TECHNICAL SERVICE BULLETIN

25-2350

"Steering Assist Fault Service Required" Message In The IPC And Reduced Steering Assist With DTCs U3008 And/Or U3009 Stored In The PSCM

Ford 2025 Explorer
Lincoln 2025 Aviator

Figure 1

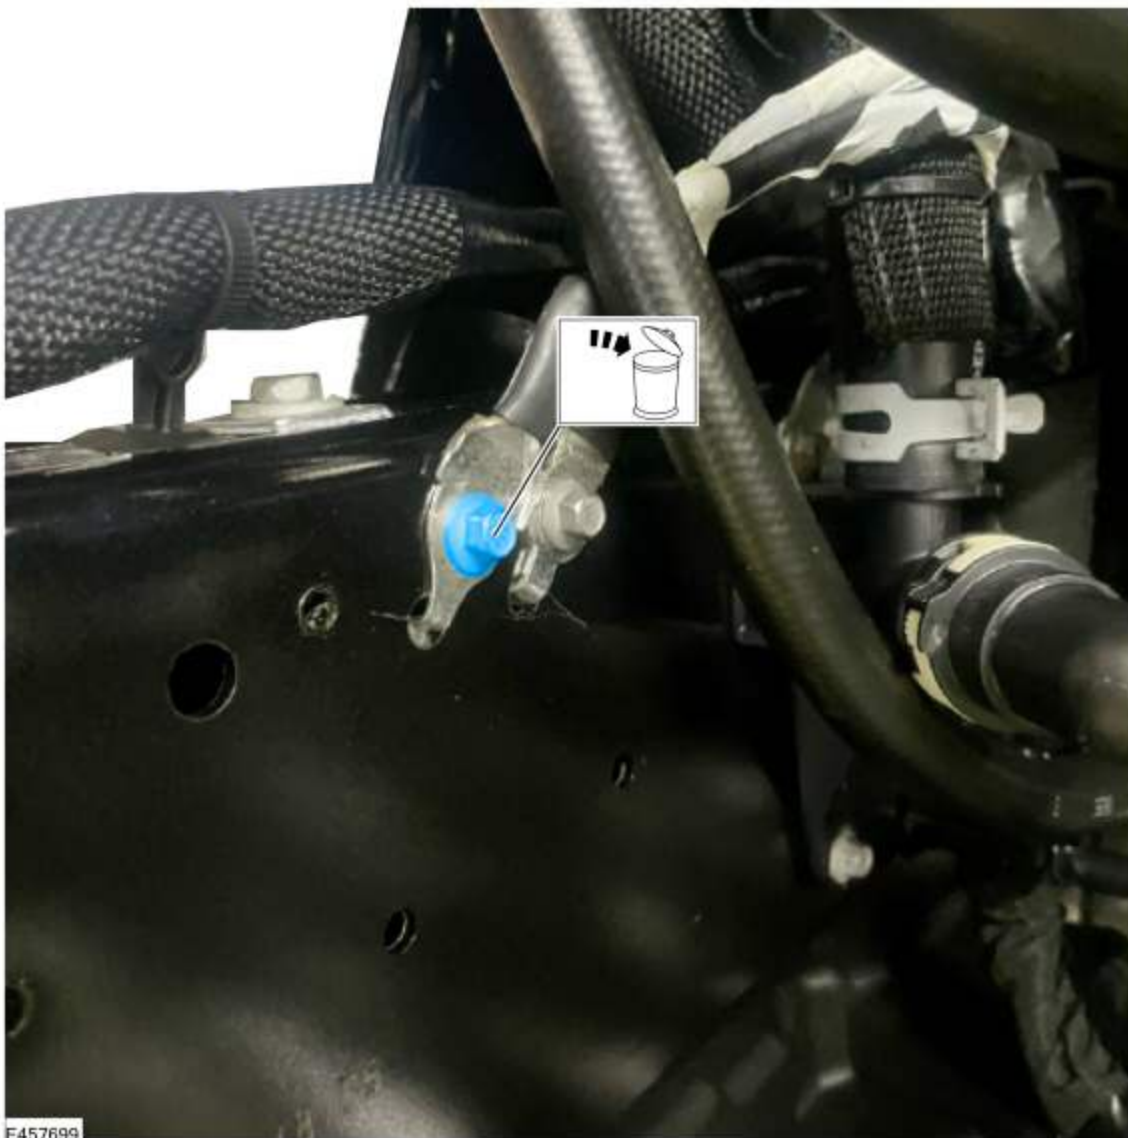
1. Using the latest version of the FDRS scan tool, download and run the "Self-Test" application and select "Run ALL CMDTCs". Is DTC U3008 present in the PSCM?
 - (1). Yes - proceed to Step 2.
 - (2). No - proceed to Step 7.
2. Remove the engine front undershield. Refer to WSM, Section 501-02 > Removal and Installation > Engine Front Undershield.
3. Remove and discard the M6 fastener from ground G104 (Explorer) or G116 (Aviator) on the passenger side frame rail. Refer to Wiring Diagram Cell 151 for connection locations. (Figure 1)

4. Carefully enlarge the existing holes in the frame rail sheet metal and the harness eyelet by drilling with a 7 mm (9/32 in.) drill bit.
5. Reinstall ground G104 (Explorer) or G116 (Aviator) using the new self-tapping M8 fastener. Make sure the ground eyelet locating tab is properly aligned with the alignment hole in the frame. Tighten to 71+/-11 lb.in (8.0+/-1.2 Nm).
6. Install the engine front undershield. Refer to WSM, Section 501-02 > Removal and Installation > Engine Front Undershield.
7. Using FDRS, download and run the "Self-Test" application and select "Run ALL CMDTCs". Is DTC U3009 present in the PSCM?
 - (1). Yes - proceed to Step 8.
 - (2). No - repair is complete. If further diagnosis is necessary, refer to WSM, Section 211-02 > Diagnosis and Testing.
8. On Aviator vehicles, remove the wiring harness retainer from the ground G119 stud bolt to access the bolt. (Figure 2)

Figure 3

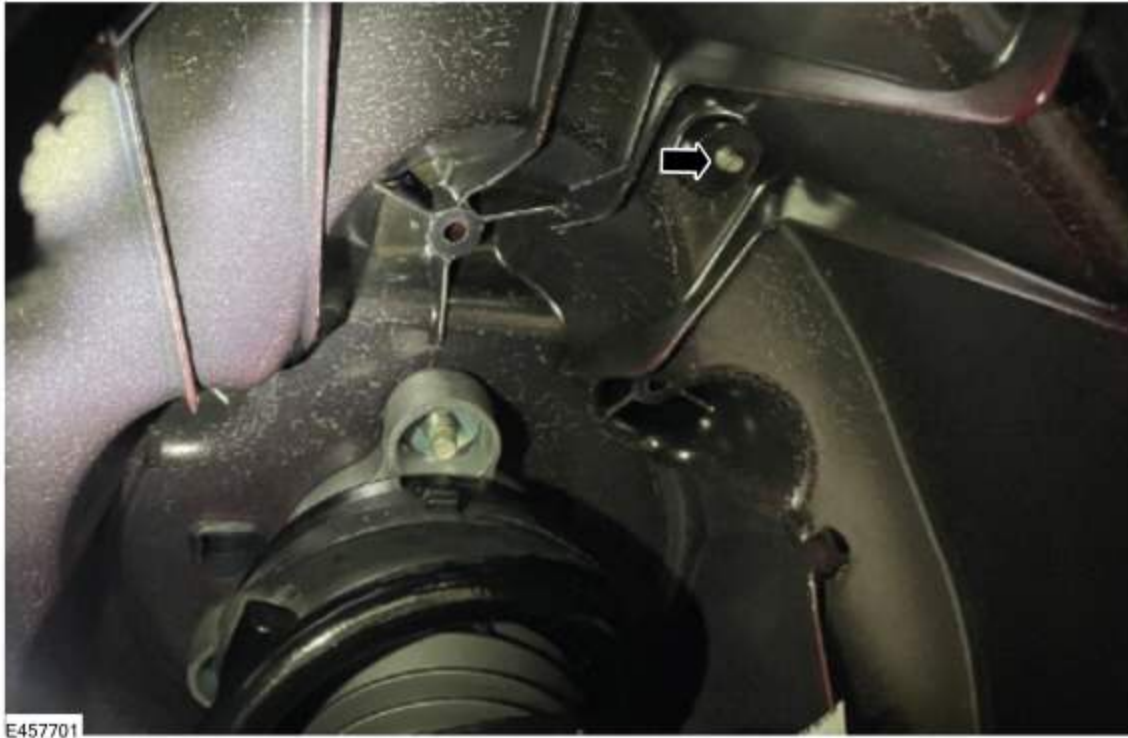
9. Remove the right front wheel and tire. Refer to WSM, Section 204-04A > Removal and Installation > Wheel and Tire.
10. Install the new M6 nut on the existing fastener on ground G103 (Explorer) or G119 (Aviator) on the passenger side strut tower. Tighten to 106+/-16 lb.in (12.0+/-1.8 Nm). (Figure 3)
